# Downstream design ideas

Ciprian Gal, Kent Paschke

# Bellow 4 size

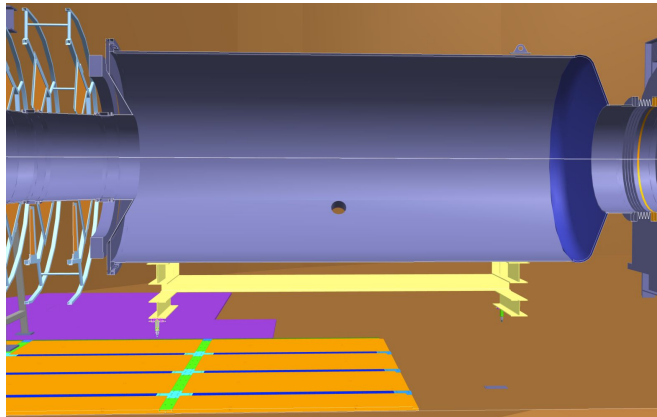
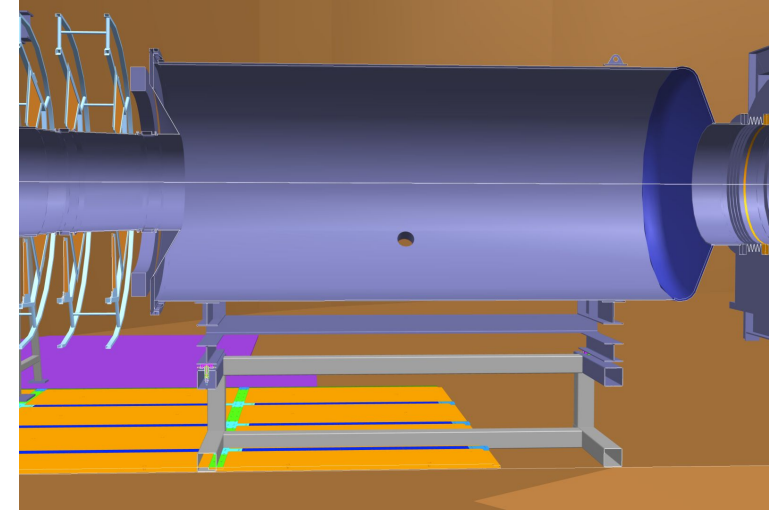
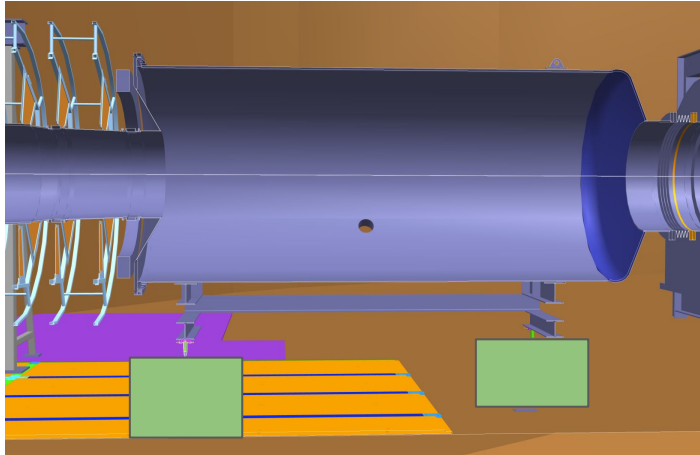
- Currently the bellows has an inner radius of 648mm
  - We still see quite a bit rescattering from this bellows getting to the main detector
  - **Would it be possible to increase the radius by 20-50mm ?**

# Drift pipe support

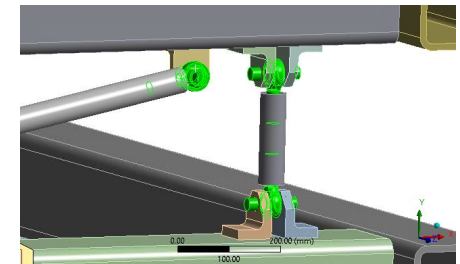
- We are worried about possible rescattering from magnetized material (like iron in steel) from underneath the drift pipe and reaching the main detector
- Would it be possible to support the pipe on concrete blocks rather than a steel structure (like top pictures)?
  - Would be worth considering this (cost wise) compared to just having aluminium frame?
- Small amounts of steel needed to connect different components can be made out of steel

# End of drift pipe

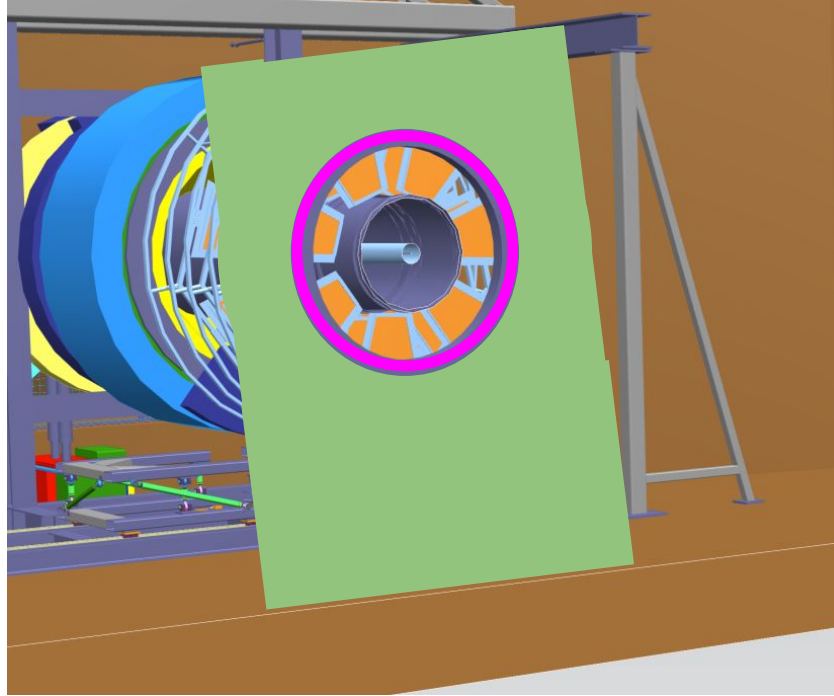
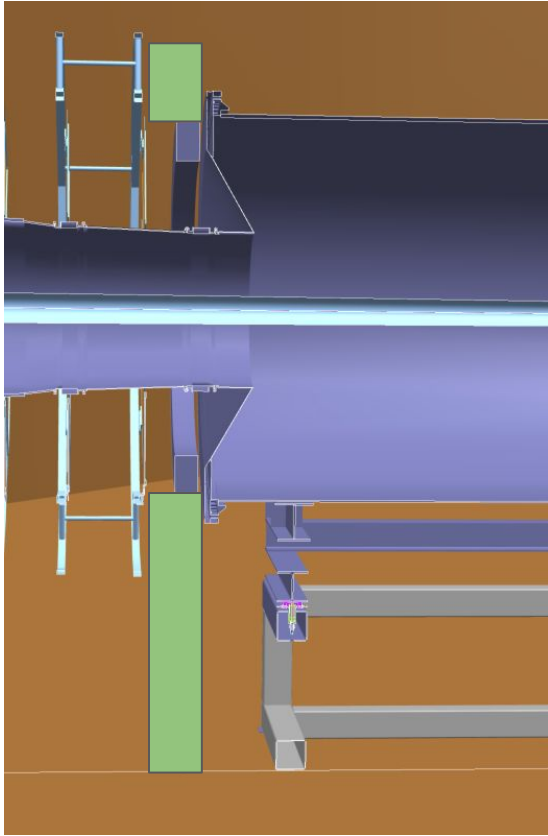
- For the support of collar2 would it be possible to build a concrete support around it?
  - We would reduce the radial extent of Pb and place the “lead edge” inside this concrete wall
- The thickness of the concrete needs to be evaluated but it probably is going to be on the level of 30cm (whatever size is better for construction is ok with us)
- To allow for integration with the GEMs and pipe (especially the protection of the thin window) we could move the GEMs back or reduce the longitudinal extent of the drift pipe.
